From: James Gaslevic
To: wayne.massie@ge.com
Date: 9/6/2006 7:31:09 AM
Subject: Fwd: Time Histories

Attached is a zipped folder that summarizes the checks we made on the adequacy of the GE time histories. We previously discussed these results with Tom Cheng. As a result, we recommend that they be provided to GE for their evaluation so as to eliminate any future concerns we may have for their use in building evaluations.

GE ESBWR ENVELOPE CRITERIA FOR HORIZONTAL CONTROL BLDG MOTION

GE-H2.SPNUREG.CRD

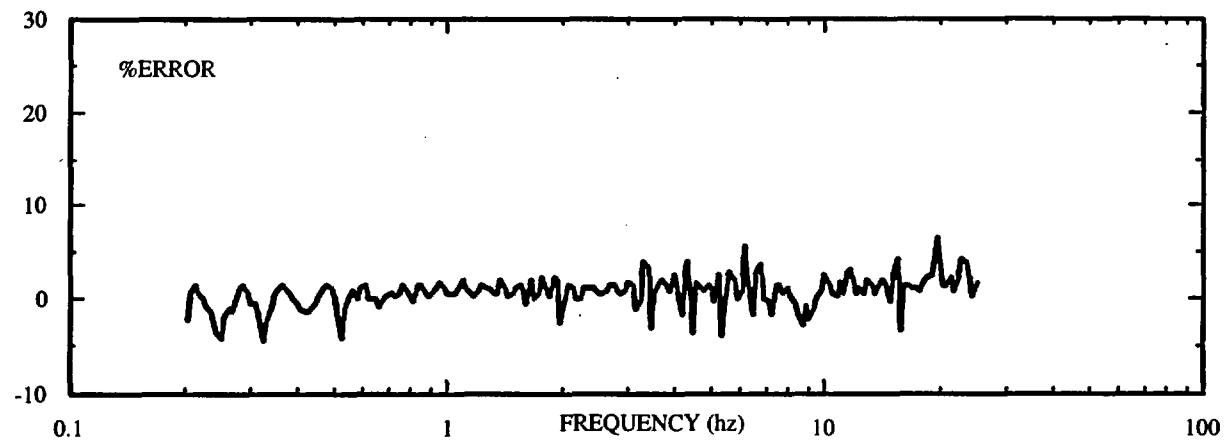
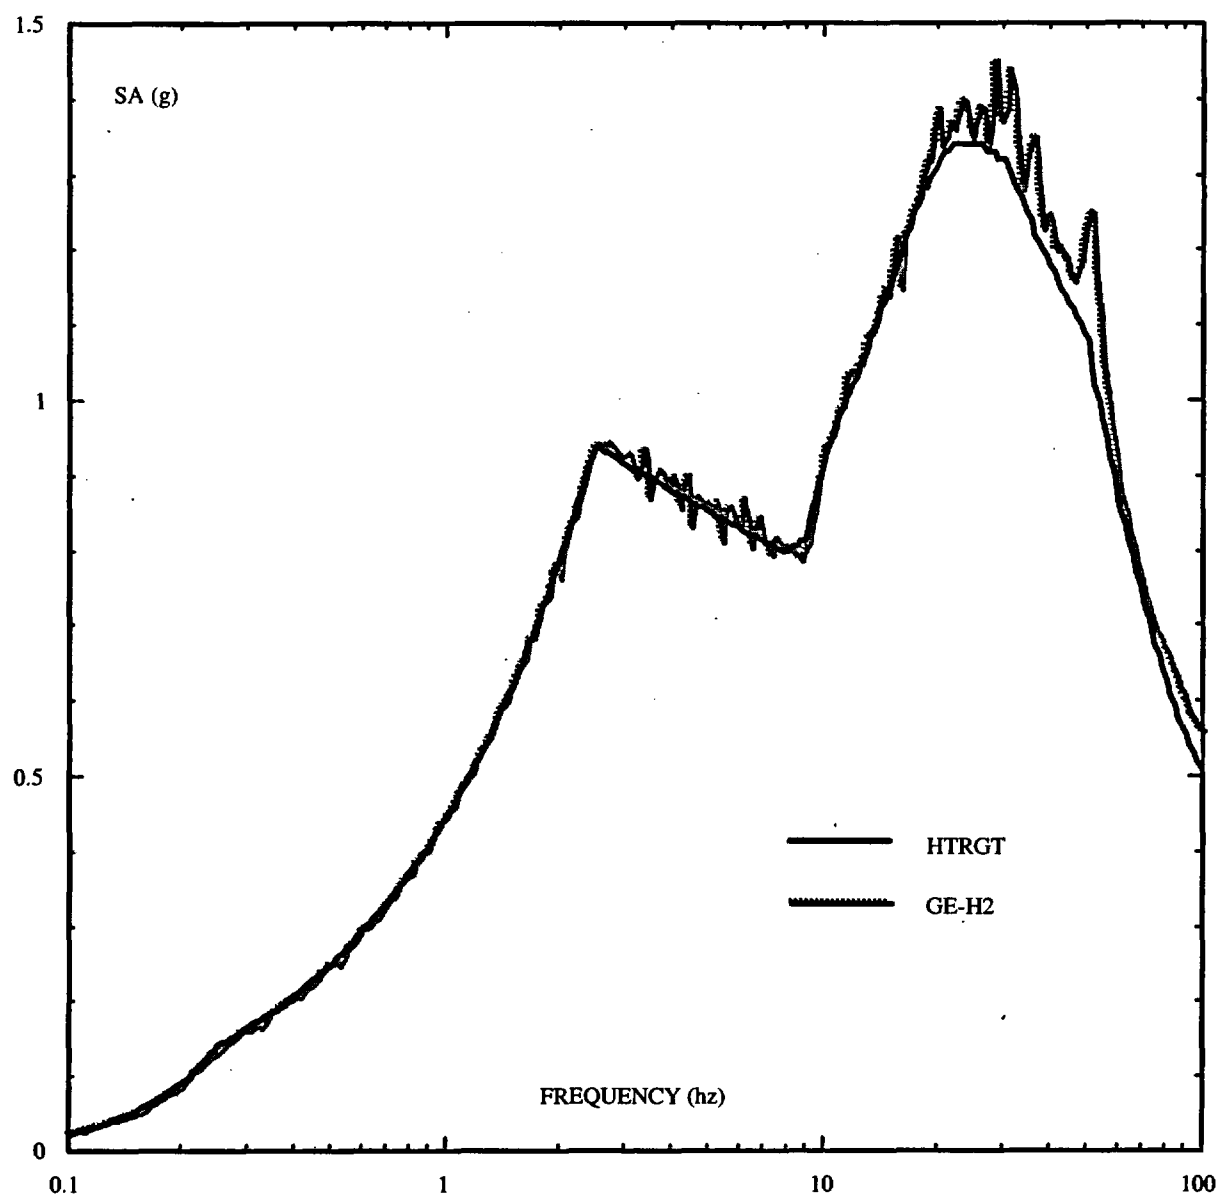
NO. OF NUREG SPECTRA POINTS FALLING BELOW 90% OF TARGET = 0

NO. OF NUREG SPECTRA POINTS ABOVE 130% OF TARGET = 0
